Service Bulletin No. 632B
(Supersedes Service Bulletin No. 632A)
Engineering Aspects are
FAA Approved

SUBJECT: Identification of Connecting Rods with Non-Conforming Small End Bushings

REASON FOR REVISION: Clarified MODELS AFFECTED; added NOTICE on page 1; clarified Steps 1.B and 4.B in "Required Action"; under the "Connecting Rod Bushing Press-Out Verification Procedure" - deleted Step 1 (reference to SB-630), added new Steps 7, 9, and 10 and new Figure 9 for better measuring procedure for indication of bushing movement, clarified the NOTICE after Step 11.A.(2) on page 5; added text to "use new seals and gaskets" in Steps 11.A.(4) and 11.B.(2) on pages 5 to 6; added IO-580 and AEIO-580 engine models to row for LW-12034 in the Top Overhaul Gasket Kit table on page 9

Figure 9

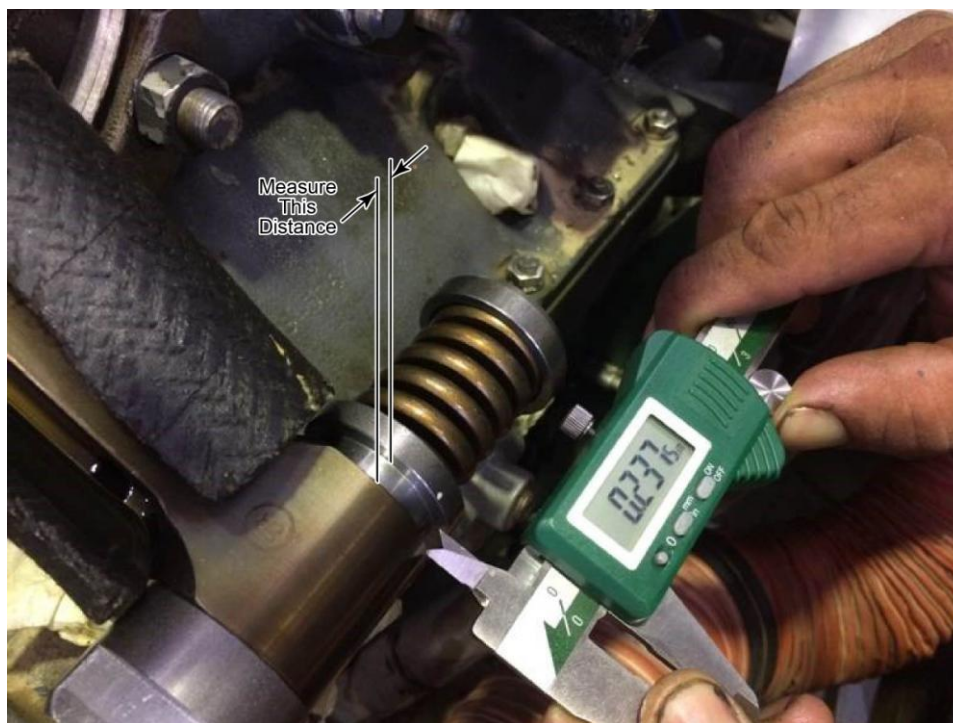
6. Use a marker to make a reference mark on the bolt head (Figure 7) to ensure an accurate count of the required number of turns during the procedure.
7. Measure the distance from the collar on the center section of the ST-531 to the edge of the connecting rod (Figure 9).

9. Re-measure the distance from the collar on the center section of the ST-531 to the edge of the connecting rod (Figure 9).
10. If the collar to connecting rod measurement has changed after turning the bolt six full turns, the connecting rod bushing has moved.
11. Turn the bolt counter-clockwise until the bottom section can be removed from the ST-531 and the tool can be removed from the connecting rod.
 - A. If the connecting rod bushing has moved:
 - (1) Order new parts as necessary. Refer to the “Parts Required Table” in the “Parts Required for Reassembly” section of this Service Bulletin.
 - (2) Remove the connecting rod assembly from the affected engine per the “Connecting Rod Removal” procedure in this Service Bulletin.
